December 12, 2019

**Re: Subsurface Conditions Report Addendum - Revised
Point Wells Redevelopment
Unincorporated Snohomish County, Washington
17203-57**

In this letter, we provide additional geotechnical information to address items in Snohomish County's May 9, 2018 Supplemental Staff Recommendation document, the County's May 9, 2018 landslide hazard area memorandum (from Randolph Sleight), and the County's June 1, 2018 Findings of Fact/Conclusions of Law document for the hearing examiner. We clarify project geotechnical information provided in the Subsurface Conditions Report (Hart Crowser 2018) and provide supplemental geotechnical information for the Point Wells Redevelopment (Project) in unincorporated Snohomish County, Washington. This letter is an addendum to our April 20, 2018 Subsurface Conditions geotechnical report. Subsequent sections are organized using the general headings from the County's May 9, 2018 Staff Recommendation document.

Point Wells Richmond Beach, Washington	
Liquefaction and Slickenside Potential in Generalized Subsurface Cross Section G-G'	
17203-57	11/19
	Figure 9A

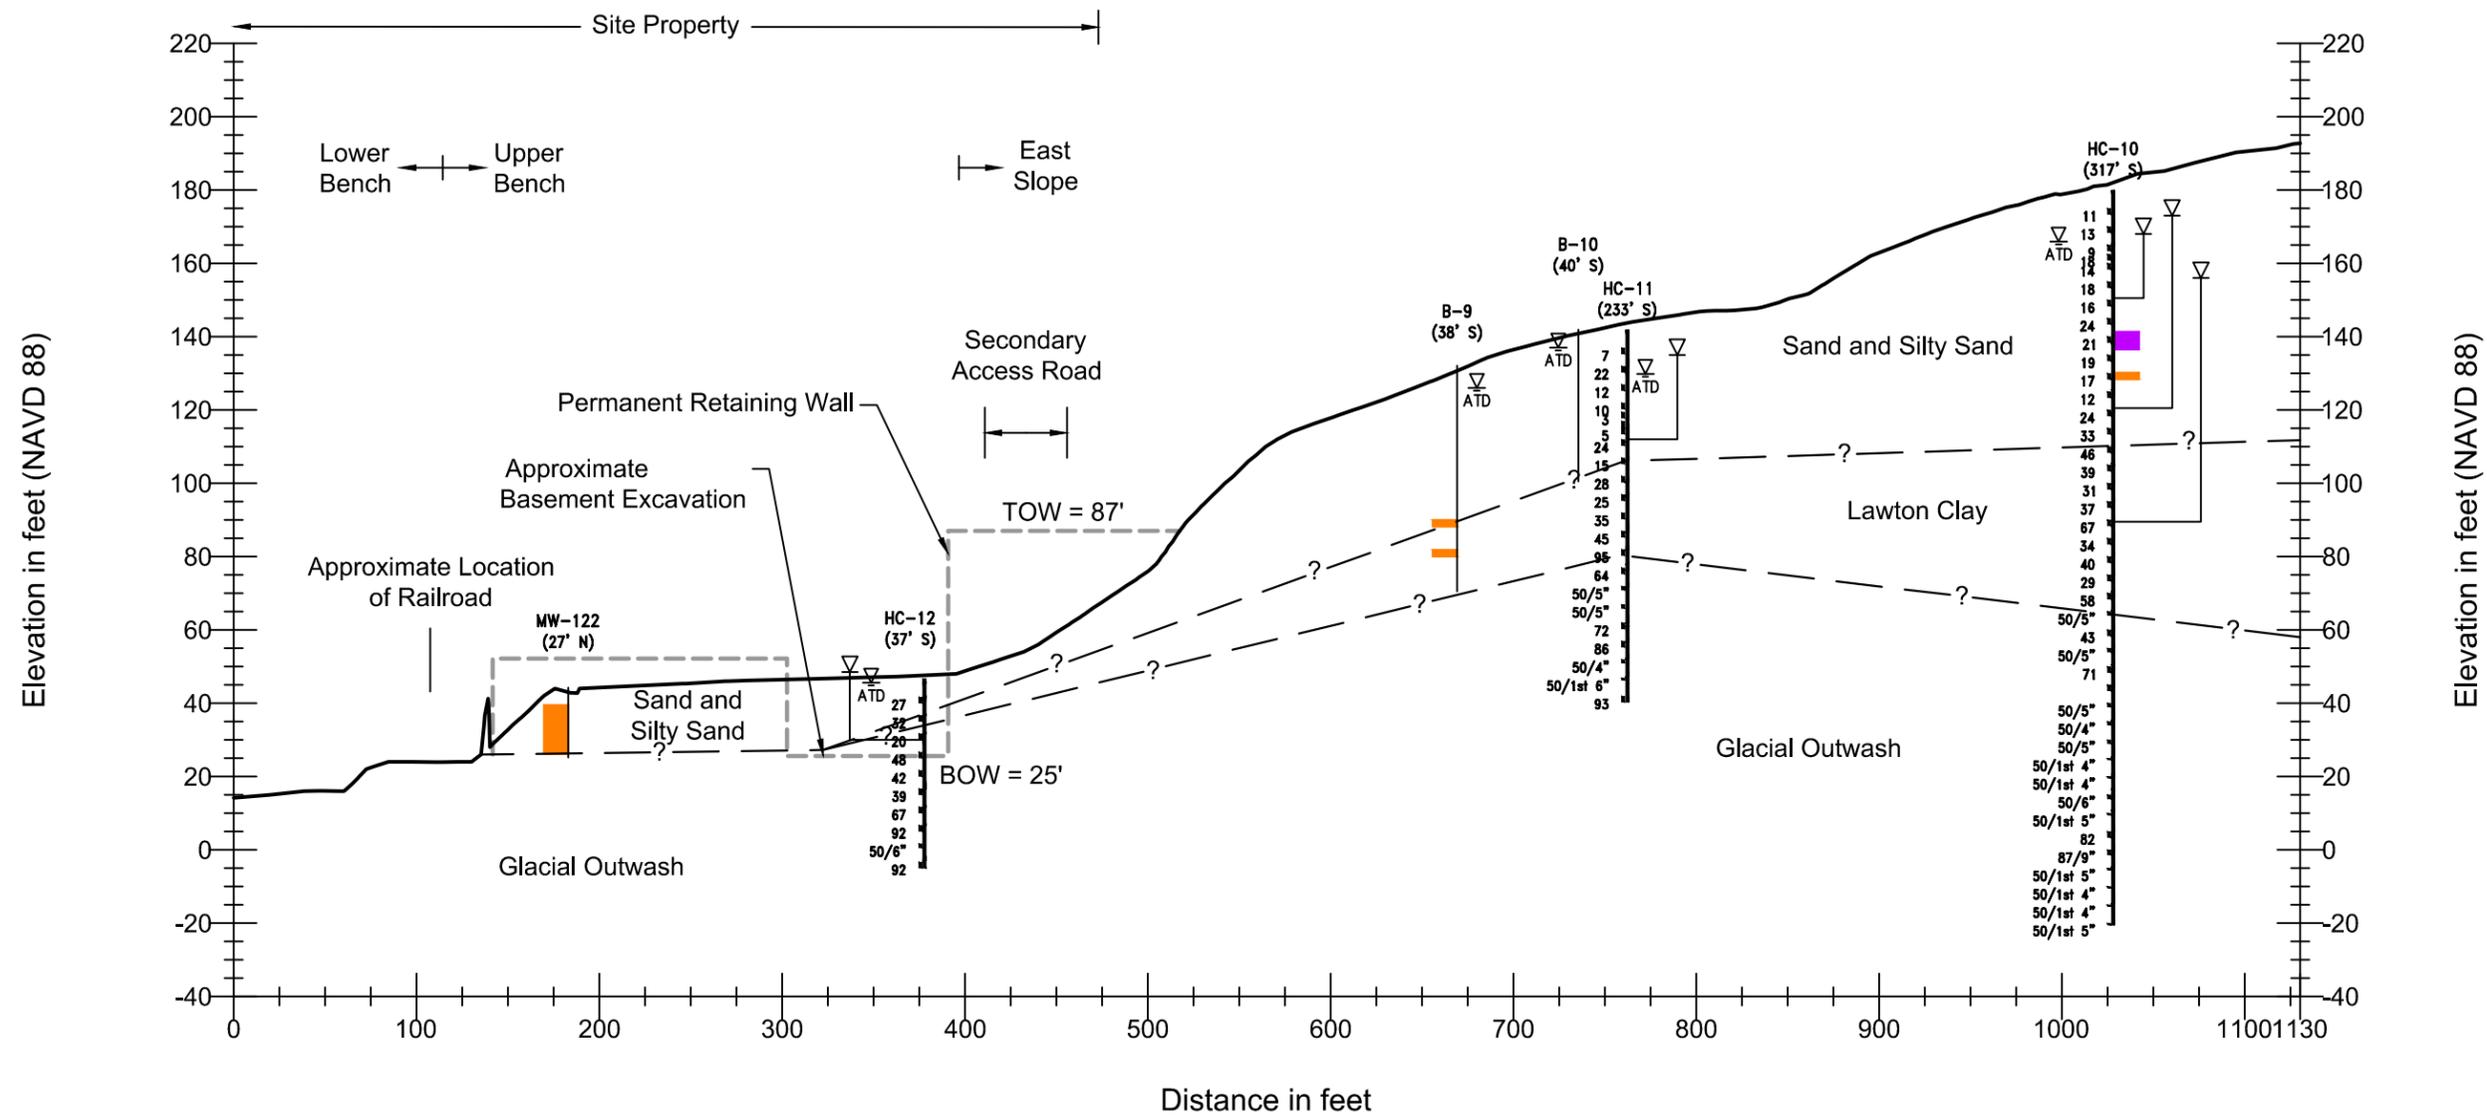
may liquefy in the event of a design-level earthquake, although these are thin (generally 1- to 4-feet thick) and discontinuous within the slope (see Figure 9A). Some shallow areas of soil that exhibit liquefaction susceptibility do exist, but these are above the measured groundwater table, and thus will not liquefy. The groundwater table in the area of the Secondary Access Road has shown very minor fluctuation (less than a few feet in Table 2) for the duration of our measurements, suggesting saturation of these areas is unlikely.

Section G-G'
Wall with Backfill, Static

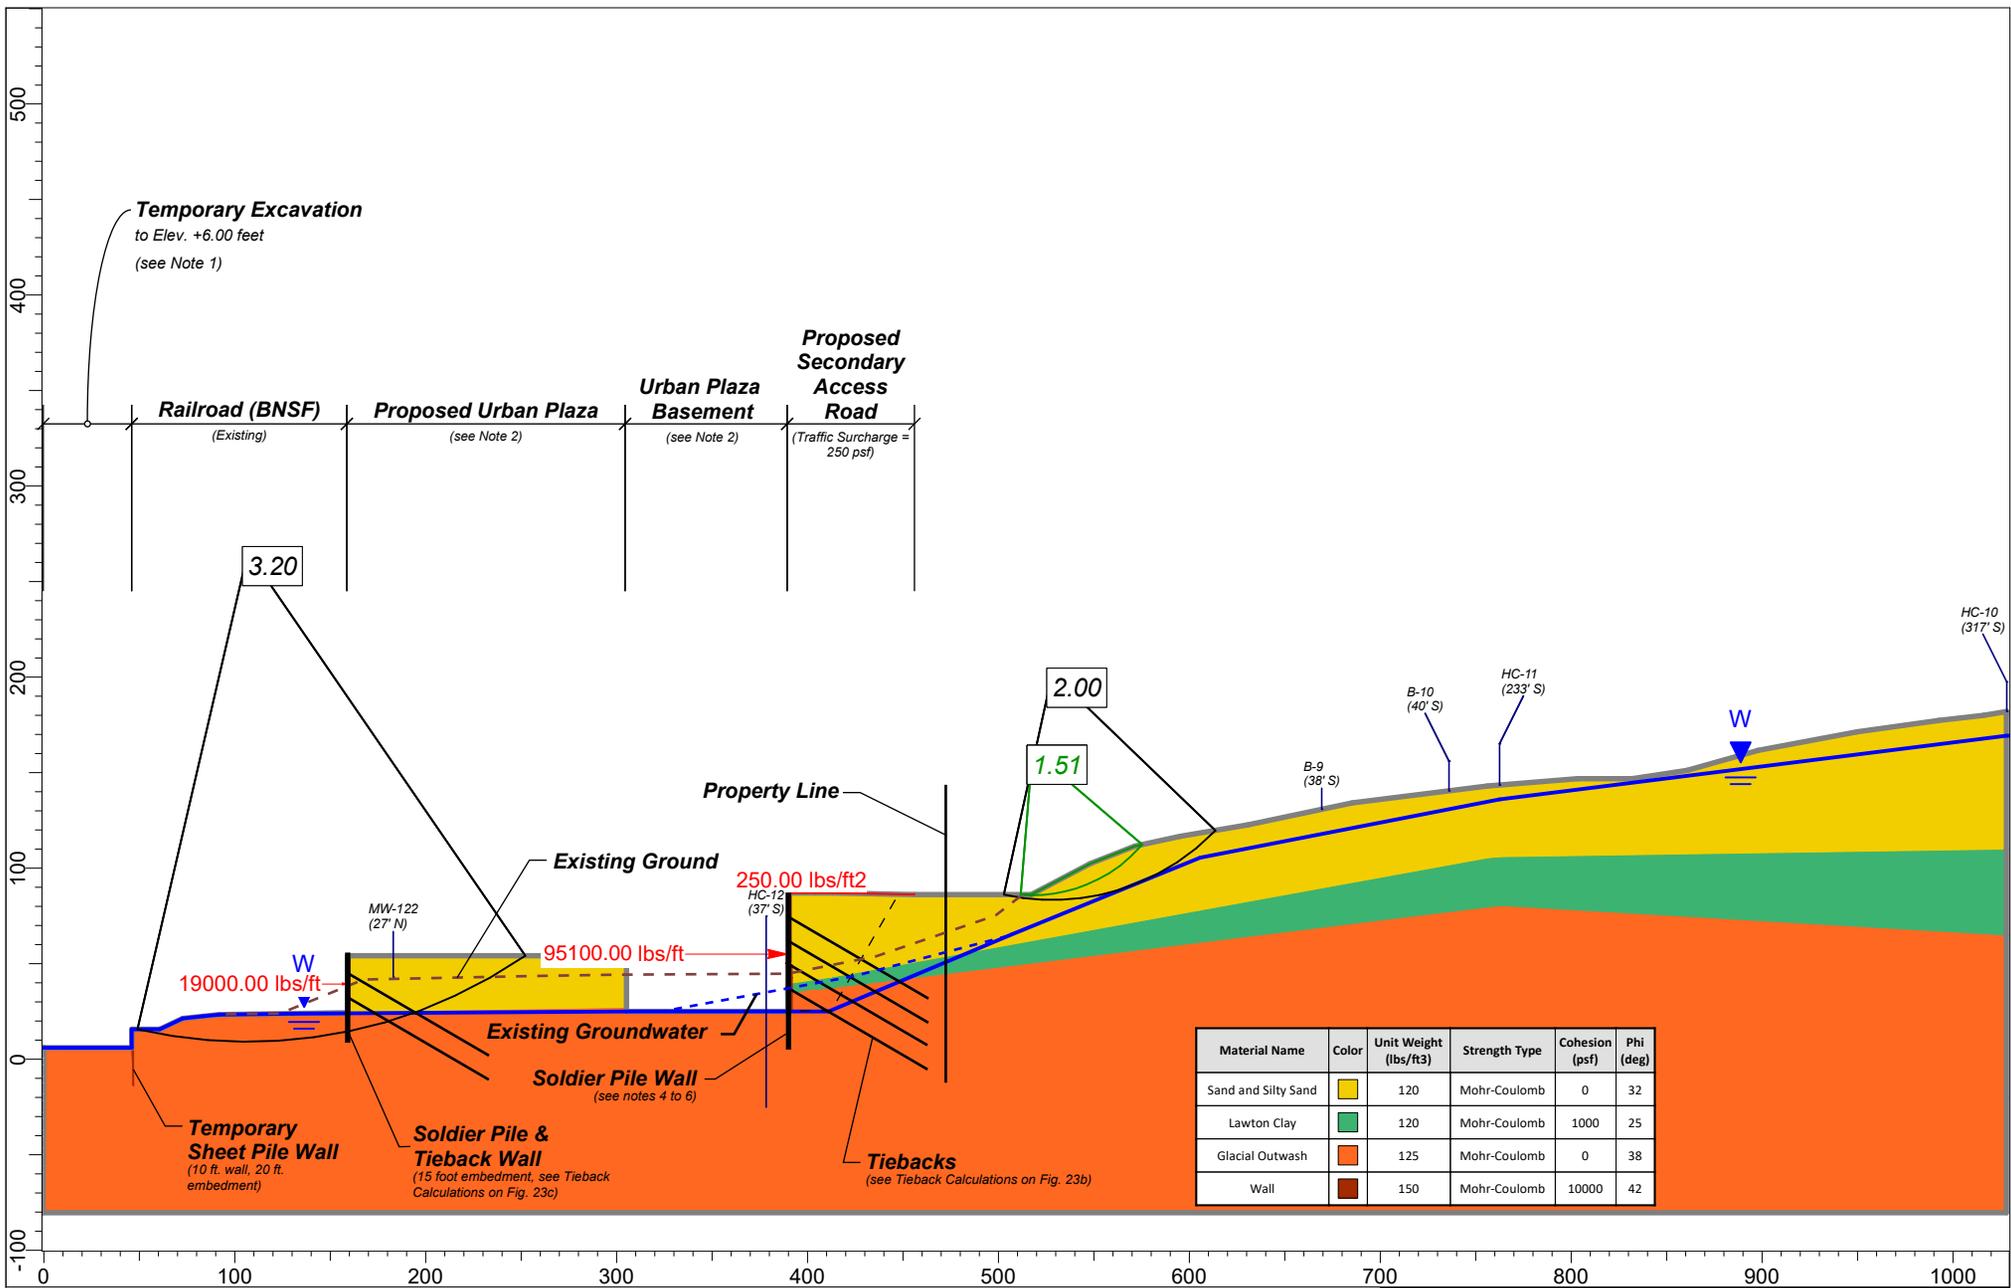
- Geotechnical slope stability analysis/calculation results on Figures 22a, 22b, 23a through 23d show how a generic retaining wall providing a resisting force of 77 kips (kip = 1,000 pounds) per foot of wall length increases FS to the County code-required values. Several retaining wall options could be used. The critical seismic case on Figures 23b and 23c demonstrate with calculations how a permanent soldier pile and tieback retaining wall system is feasible to provide these resisting forces (including soldier pile and tieback geometry and loads). Note the following specifics about the stability analysis.

- Figures 22a and 23a include excavation west of the railroad to an elevation of +6 feet, showing FS above the code-required values. This excavation would be temporary for either removal of contaminated soil or construction of building basements and would likely include sheetpile shoring. Final grades just west of the railroad will be raised to about an elevation of 50 feet, which will act as a resisting force to potential global instability extending from the east slopes under the railroad, which is unlikely. These figures only show the two minimum/critical slip surfaces above the proposed retaining wall and west of the railroad. However, the analysis included larger surfaces starting above the retaining wall and extending under both the retaining wall and the railroad; but, the safety factors were well above the code-required values.

Section G-G'
Wall with Backfill, Static with Snow Load

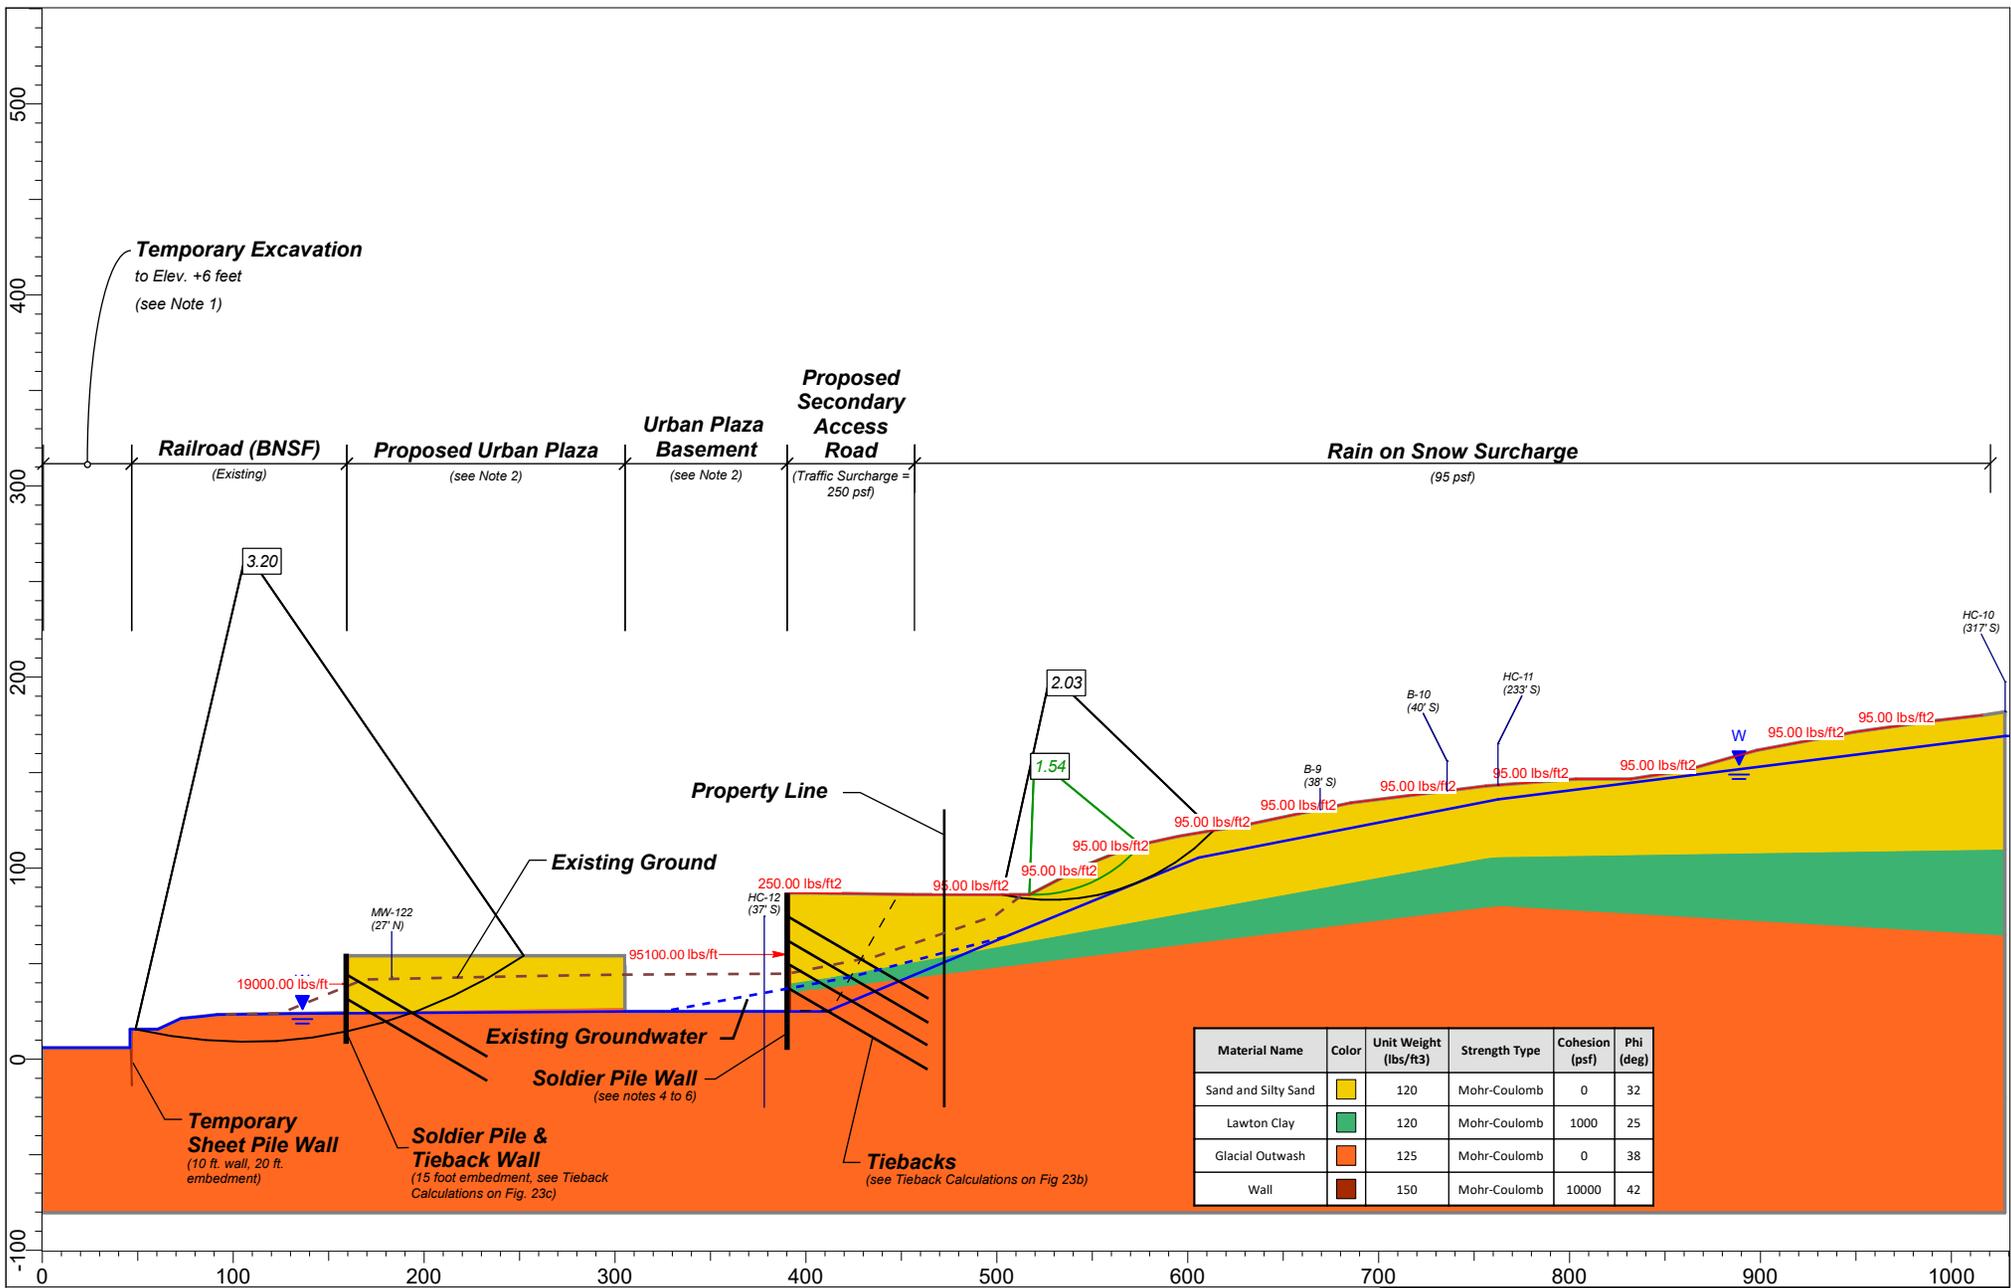
- The stability results on Figure 22b include a rain on snow surcharge of 95 psf (equivalent to 1.5 feet of water). This is included for the static case only since it is an extreme event that is unreasonable to combine with the seismic extreme event.
